**CORRO-CONSULTA**

**MEMORANDUM – REDACTED VERSION – JULY 19, 2007**

**Subject:** Update of Current Knowledge Regarding the State of Integrity of OCNCS Drywell Liner and Comments Pertaining to Aging Management Thereof

**Subject: Review of Fitness for Service Assessment of Oyster Creek Dry Well  
on the Basis of Extended Data Analysis**

Figure 2

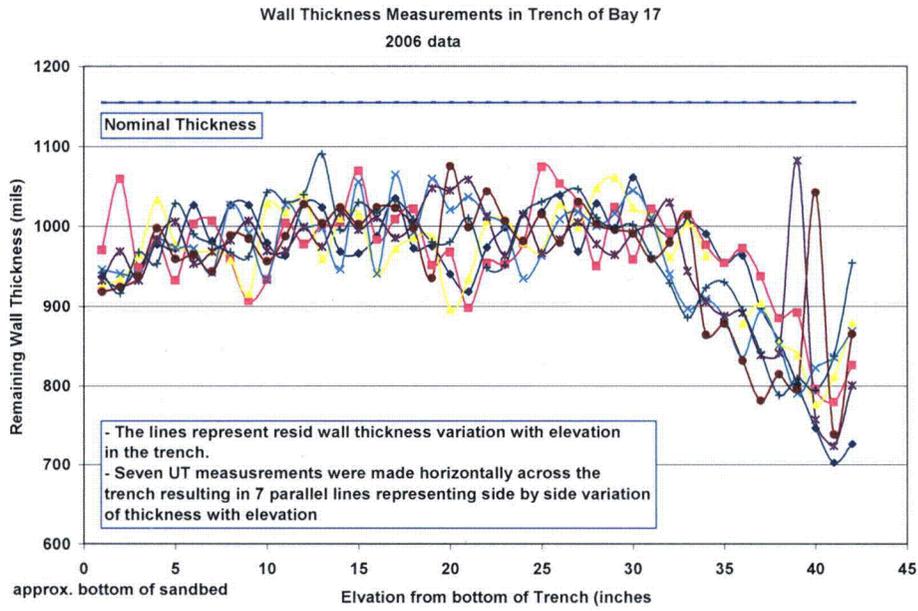
We take issue with this statement. In support of this contention, an effort was made to show graphically the remaining wall thickness observed in all of these various locations. Thus Figure 2 shows, by way of example, the remaining wall thickness from the 2006 UT measurements made with the help of 6 by 6 inch grids as a function of elevation in the **trench of Bay 17**. It is understood, as is described in Ref. 3 that 6 such grids were placed one on top of the other in the trench in order to capture the corrosion from the bottom to the top of the sandbed. Hence, if the bottom of the trench had the elevation about 9 feet, then the top of the 6 grids would have had an elevation of about 12 feet, which according to Figure 1 corresponds to the top of the sandbed and is at least 9 inches higher than the top of the grid used for UT measurements from the inside. (Note, none of these elevations is terribly accurate, however, the top of the trench measurements were definitely lower (deeper pits) by a good margin than the inside grid measurements). Figure 2 plots all individual 2006 measurements from the trench in bay 17. The 6 traces represent the variation of the wall thickness in the horizontal direction while the traces themselves extend from the bottom of the trench (left hand side) to the top of the trench (right hand side). The

undulations of the 6 traces, which are at times (at the same elevation) in synch and at other times out of phase clearly depict the nature of the “golf ball type” surface described in AmerGen literature (Ref. 1 pg. 4). Where the undulations are in synch one can estimate that the extent of the pit at that location extends over an area larger than just one inch in diameter<sup>3)</sup>. It should also be noted that the average amplitude of the undulations in Fig. 2 are of the order of 0.1 inch, i.e. the roughness of the surface at this point is only of that order of magnitude. AmerGen estimated the “roughness” of the surface to be rather of the order of 0.2 inches (Ref. 5 pg. 5).

The most striking observation is that the corrosion is most severe at the top, almost uniform in severity over most of the depth of the sandbed and again somewhat more severe at the very bottom.

Figure 3

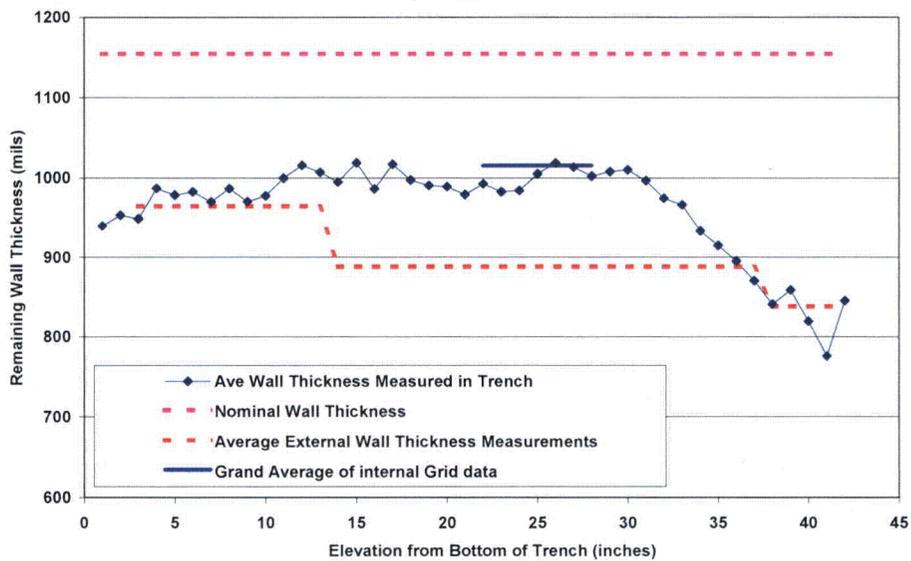
In Figure 3 an effort is being made to compare the average remaining wall thickness from trench measurements (averaged over the horizontal direction) with the average of the 6 by 6 grid measurement from the inside and the direct UT measurements from the outside. Also graphed in this figure are the averages of the outside measurements for the three zones for which data are reported (Ref. 5). What one can see is that the averages for the grid and the trench data overlap quite well at the same elevation. However, the average outside measurements are significantly lower at comparable elevations.<sup>4)</sup> This is probably because the choice of location for the external measurements was deliberately biased towards thin spots.

Figure 4

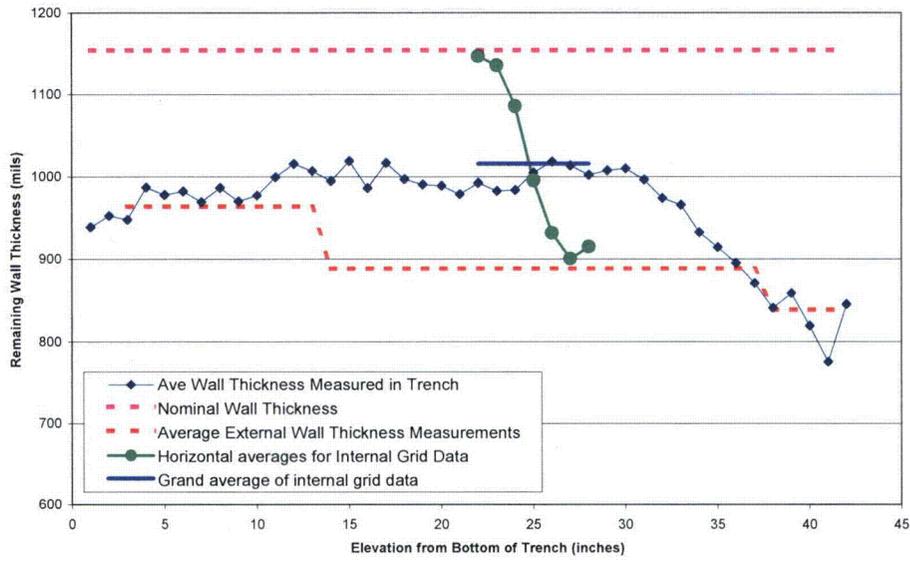
Finally in Figure 4 we see the spread of the 6 by 6 inch inside grid measurements superimposed on the averages of the other measurements.

**Conclusion:** What the superposition of the UT measurements in Bay 17 demonstrates is that wall loss ranges from zero to 33 percent, however, only the trench and outside measurements come close to represent the most severe corrosion at the highest elevations. It should also be remembered that the grid measurements at the inside curb cutout as well as those in the trench are only 6 inches wide. One does not have, therefore any indications as to how far serious corrosion may have spread laterally around the circumference of the bay.

Figure 5

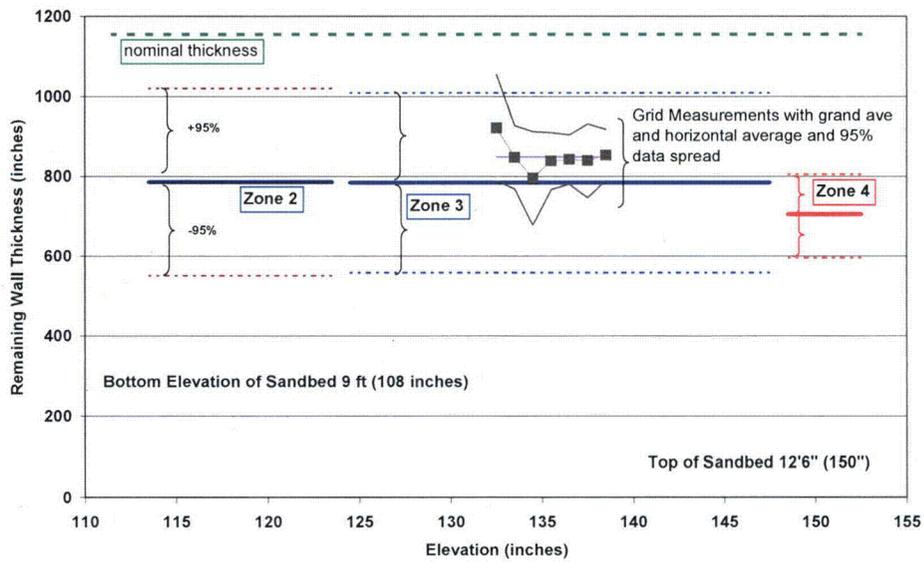
Figure 5 shows an analysis of the available 2006 data for Bay 13. Bay 13 is probably the second worst corroded bay apart from Bay 1. The averages for the external measurements for each zone are fairly similar, as are the 95% limits for the data spread. There is a 95% percent probability for the deepest penetration to be of the order of 48% of the original wall thickness. The superposition of the internal grid data shows a higher average and a narrower distribution of the data spread. Again one recognizes that the internal 6 by 6 inch grid measurements do not represent the worst corrosion degradation.

Figure 6

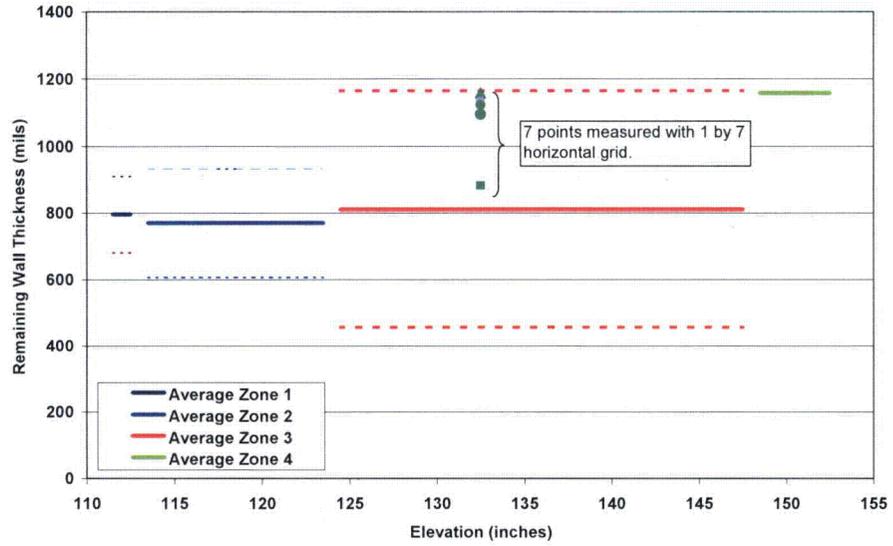
Finally in Figure 6 we show the distribution of the external measurements for Bay 1. One observes that the 95% lower limit of the data spread is around 40% of the original wall thickness, or indeed at a remaining wall thickness of 450 mils, which is 0.04 inches below the required sandbed thickness for the Design Pressure and Temperature. Because the external sampling in Bay 1 was designed to capture the thinnest points, this is a conservative estimate of the minimum wall thickness. However, given the need for a very high degree of confidence that the drywell shell is ready to withstand accident pressures and the uncertainty created by the sparse data set, I believe that a conservative approach is required in this case.

Figure 7

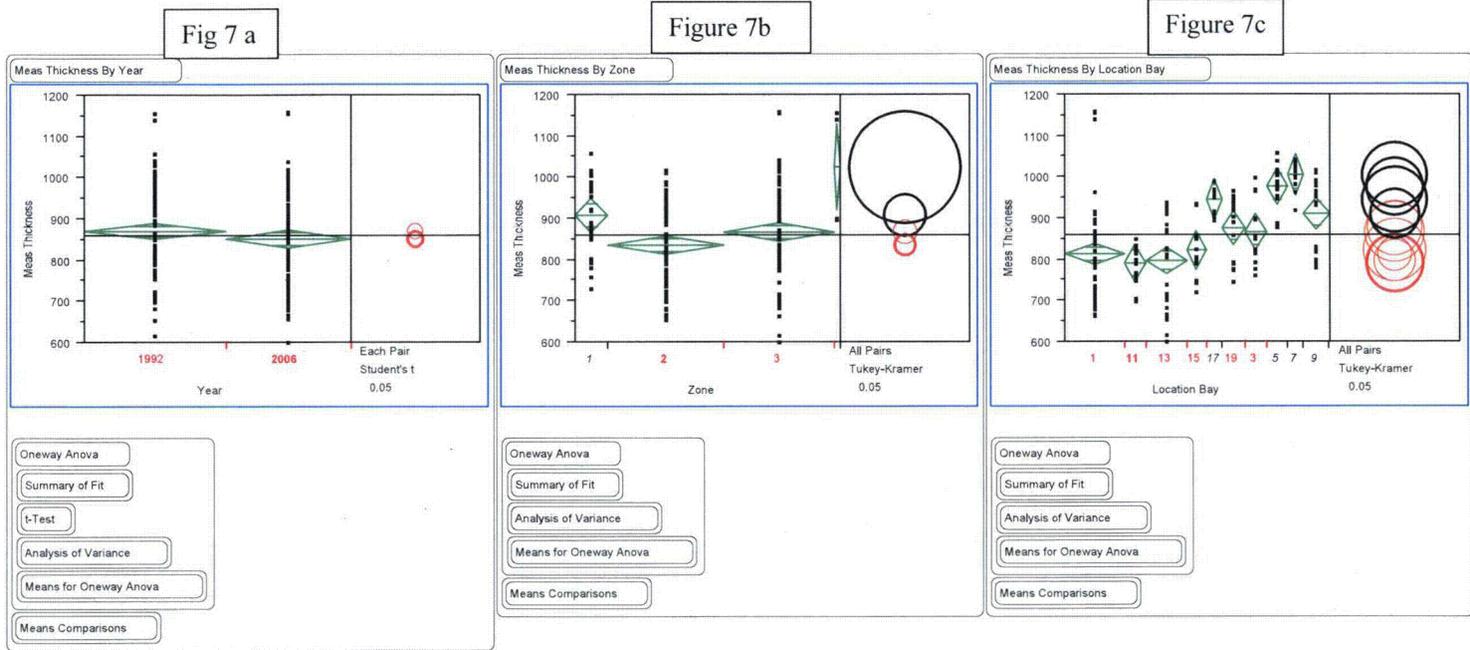
It was found that there is no significant effect of the time (Fig.7a). While there is a decrease of 19 mils between 1992 and 2006, this difference is not statistically significant within the variability of the data. The differences between the zones, however are significant. Zone 2 is by far the most corrosive zone. When the bays are compared, one finds as expected that some bays have experienced little corrosion in contrast to others. The importance of these observations is obvious: they point again to the fact that the intensity of corrosion is a clear function of elevation and bay. Hence, averaging data and generalization may lead to doubtful conclusions.

Figure 7a: Comparison between measurements I 1992 and 2006 show no significant difference. The means from 1992 and 2006 show a bias of 0.018 inches, but the bias is statistically not significant despite of the many data points. Fig. 7b: The comparison between the "zones" (elevations) is significant. Zones 1 is significantly different from zones 2 and 3. For zone 4 there are not enough data for statistical significance. Fig. 7c: Some bays, red ones, are significantly different from the black ones.

Figure 8: External UT Measurements in Bay 15

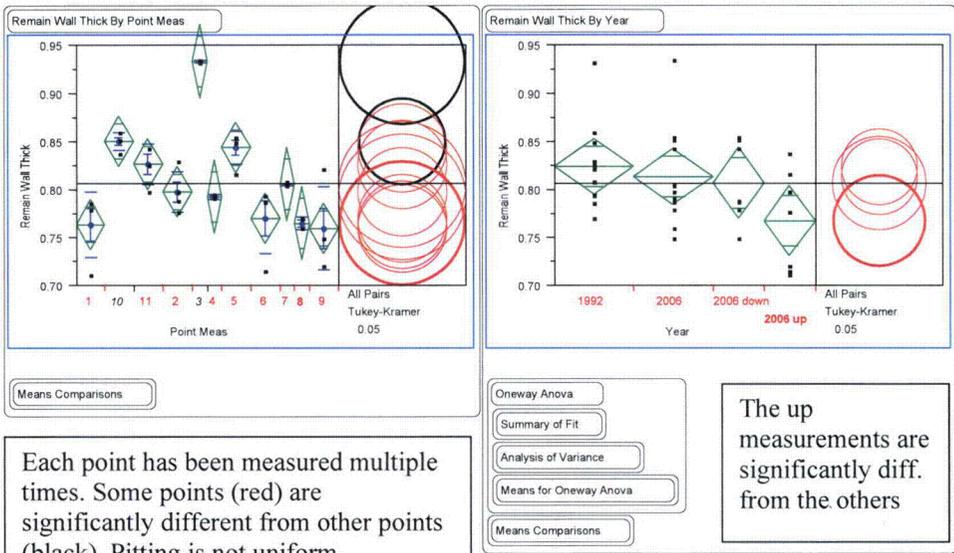
In 2006 the validity of some of the external UT measurements was explored by measuring around the nominal original locations. These data were statistically evaluated in Figures 8, 9, 10 for Bays 15, 1 and Bay 19. The additional data collected in Bays 19 and 15 had been identified as “up” or “down”, hence additional data sets

**Figure 10: External UT measurements in Bay 19**

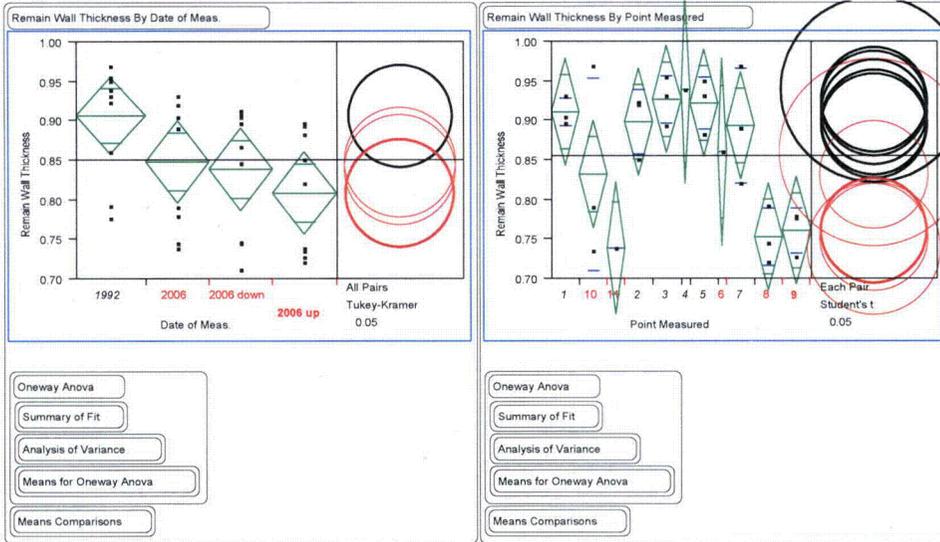
identified as 2006 up and 2006 down were compared with the original 2006 data. It turns out for Bay 19 for instance that the UT penetrations identified as 2006 up were significantly lower than the measurements of 1992 with a probability of better than 95%. The difference between the 1992 and 2006 up data is 0.1 inch. Similarly for Bay 15 one finds that the 2006 up data are significantly lower than the original 1992 data by about 0.06 inches, although this difference is not significant at the 5% level. For Bay 1 there is practically no difference between the 2006 and the 1992 data sets, because of the two or three measurements in the non-corroded areas. Summarizing these results in Table 1, one finds that the lower 95% confidence limits for Bays 1, 15 are marginally within the 0.736-inch limit. Since one does not know exactly how extensive the "cancer of corrosion" in the sand bed area really is, it is very difficult to put this interpretation in perspective with the assessments made by AmerGen relative to areal criteria for thinned areas (see discussion below).

Again one finds that the “up” measurements are significantly lower from the 1992 measurements.

Figure 1

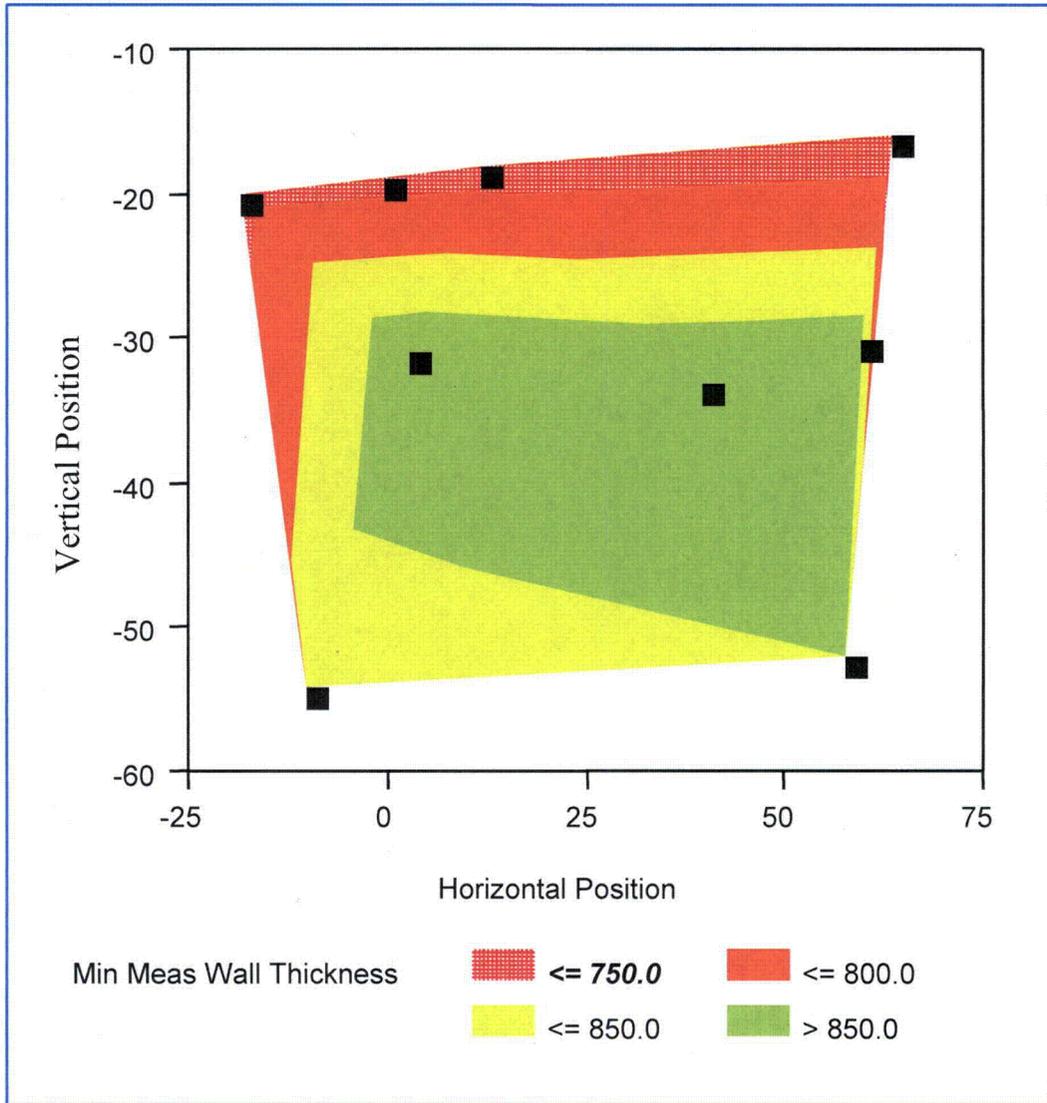
possible. However, we can look at the situation and gain intuitive insight into this question. Figure 1, which is discussed in detail below, presents areas of equal wall thickness (contours) based on the measurements, shown as the points, performed on the outside of Bay 19 in 2006. Note the dark squares are 2.5 inch on each side (and drawn to scale with reference to the horizontal axis), hence cover the area of measurement claimed by AmerGen. It turns out that the measurements at the -20 (inch) vertical position are on average less than 0.725 inches. Since measurements had not been extended to higher elevations one has no assurance that there are no more seriously corroded areas either between those measured or further up in the sandbed.

The advantage of this evaluation is that one can see all the available data in a quantitative presentation. Thus, one can see in Figure 1 that an area exists at elevation -20 (20 inches below the reference point) where the remaining wall thickness is less than 750 mils, or less than the criteria for general thinning at 95% confidence. This area extends from 20 inches on the left (-20 inches) to about 60 inches on the right (+60 inches), or about 7 feet. The width of this area in Fig. 1 is maybe 4 to 5 inches, however, because measurements were not extended toward lesser elevations (from the reference point) one simply cannot estimate how much further the serious the corrosion may extend in Bay 19.

**Figure 1** mentioned previously shows a heavily corroded area in Bay 19 at elevation -20. The extent of this area is highly uncertain because it was not further defined by additional UT measurements toward higher elevations (>-20). Indeed, one could find here an extended bathtub ring area.

**Figure 2**

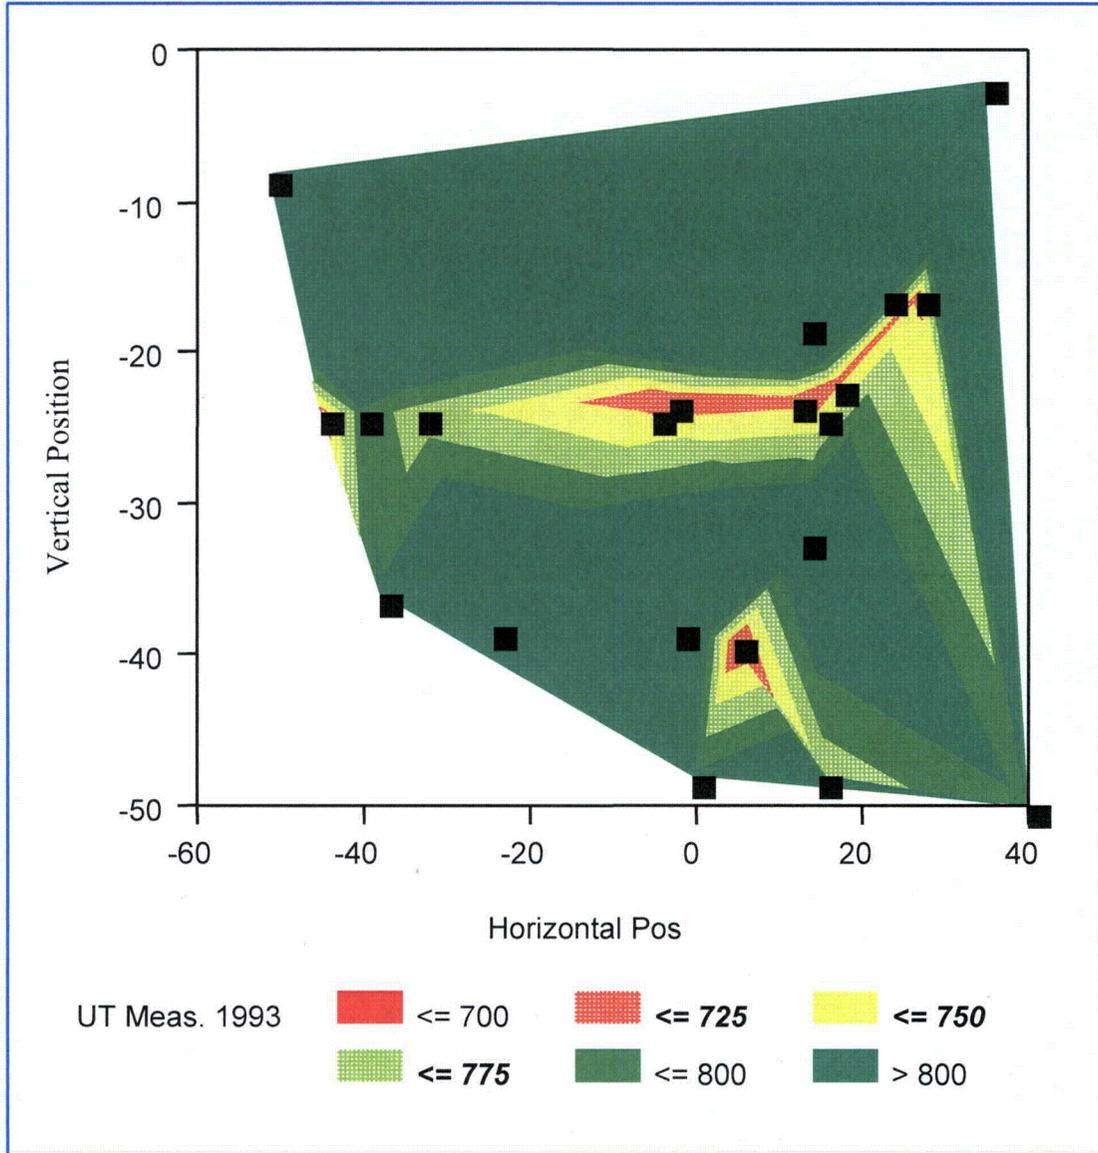
The data used for the analysis are contained in Tables 1 and 2 for Bays 1 and 13 as extracted from AmerGen documents. Presumably, these were the most corroded Bays. Figure 2 shows a contour plot for Bay 1 obtained with the data from 1992. The dimensions of the points in the plot are 2.5 by 2.5 inches. Again, one needs to remember that the specific shape of the contours depends not only on the residual wall thickness measured at the locations indicated, but on the density of measurements as well. (For instance, an additional measurement at coordinates h (-20) v (-25) could completely alter the contours and in all likelihood extend the area of wall thickness below -750 mils<sup>4)</sup>.

Nevertheless, it appears in Figure 2 that in the so called "bathtub ring" an extensive area exists with wall thicknesses between 700 and 750 mils (0.75 inches). This area extends well over 52 inches (4<sup>+</sup> feet) and is about 5 inches wide. In view of the fact that UT measurements are at best accurate with a standard deviation of about 45 mils, (95% confidence limits +/-90 mils), this area could well be more extensive.
